PUBLIC UTILITIES COMMISSION

March 03, 2022

PG&E AL 6286-E, 6286-E-A, and 6286-E-B
SCE AL 4559-E and 4559-E-A
SDG&E AL 3822-E, 3822-E-A, and 3822-E-B

Subject: Staff Disposition of: PG&E AL 6286-E, 6286-E-A, and 6286-E-B; SCE AL 4559-E and 4559-E-A; and SDG&E AL 3822-E, 3822-E-A and 3822-E-B -- Modifications to Rule 21, Generating Facility Interconnections, Pursuant to Decision 20-09-035 Ordering Paragraphs 7, 49, 50 and 52 (SCE only)

Figure 1: PCS Operation Responding to a Rapid Loss in Load

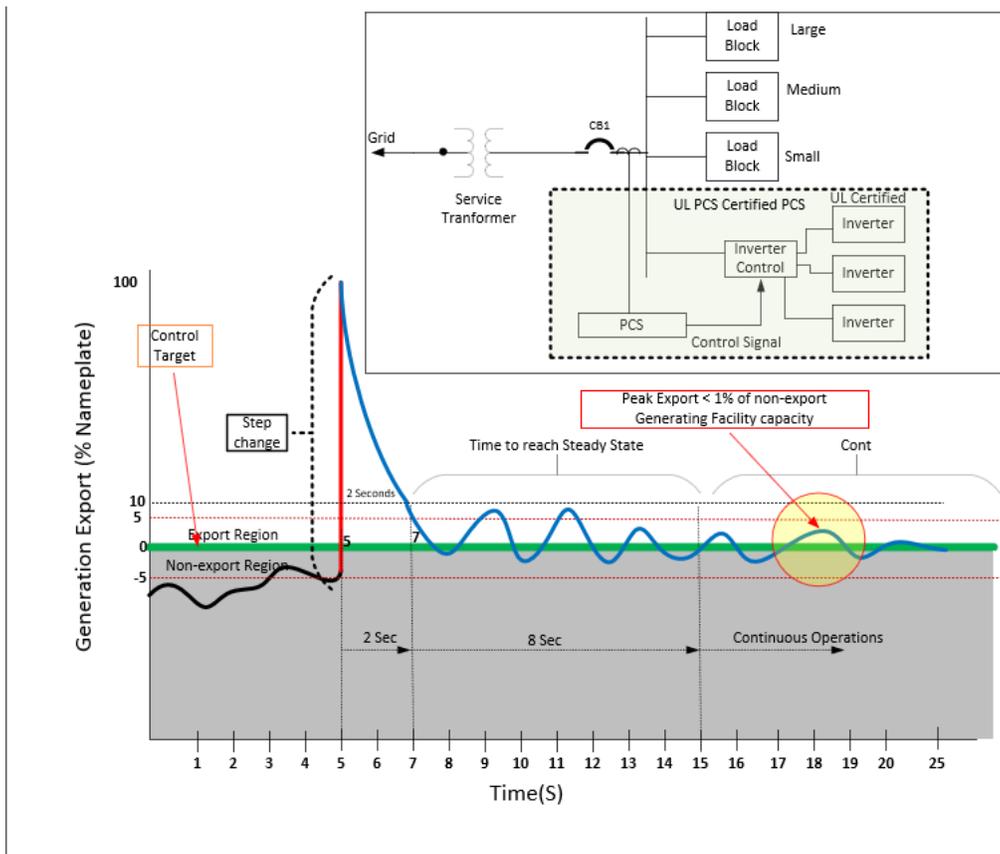
Figure 1 shows the concept of steady state for a 2 second ([s]) OLRT. Between time (t) equals (=) zero to t=5 [s] the generating facility is not exporting power to the electric grid and all power produced by the generating facility is being absorbed by the existing load (black squiggly line). At t=5 [s] there is a sudden drop in load and the facility starts exporting power to the electric grid (vertical red line the “step change”) more than the allowed limit (horizontal green line). The period between t=5 and t=7 [s] is the 2-second OLRT during which time the PCS attempts to bring the export power value back down (blue descending line) to the allowed limit. But the PCS may not reach the allowed limit within the OLRT and there could be a time after the 2 [s] OLRT where the PCS exports and absorbs small amounts of power (blue squiggly line). To account for this operation, the IOUs have added, after the OLRT, an 8 [s] period of time for the PCS to reach steady state--the PCS must reach steady state within 10 [s] (at t=15) after the step change. After t=15 [s], during continuous operation, the PCS will keep the export value bounded and below a pre-determined value.
